Serial No. 10/620,590
Amdt. Dated September 15, 2004
Reply to Office Action of June 15, 2004

Docket No. P-0520

REMARKS/ARGUMENTS

FIG. 6

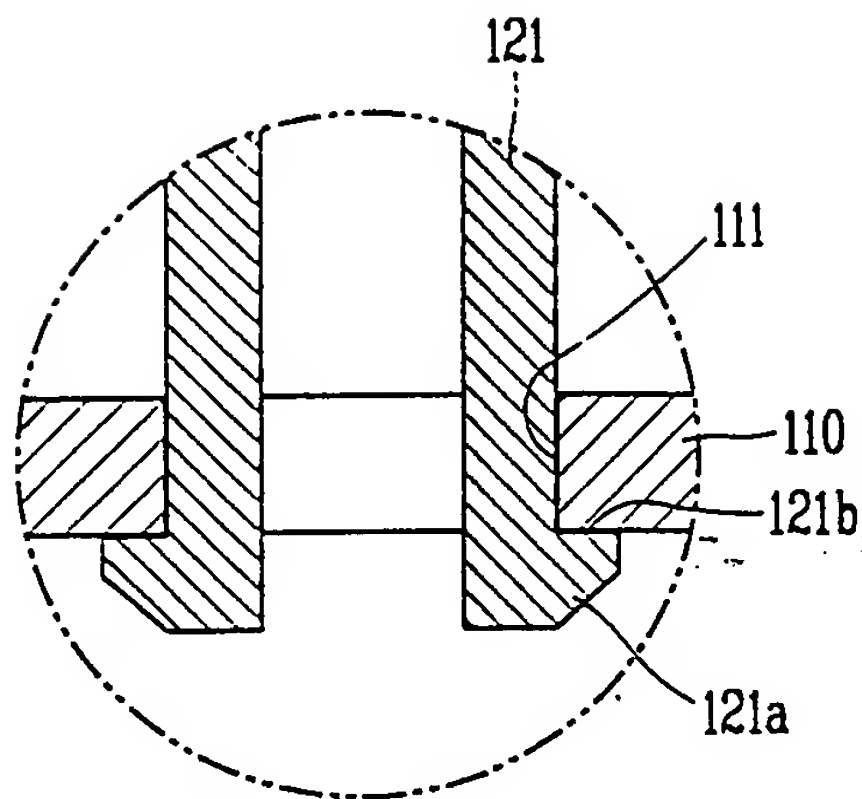
In Figure 6, one of the two reference numerals 151 has been deleted to accurately reflect the position of the hole 151 formed in the contactor 150.
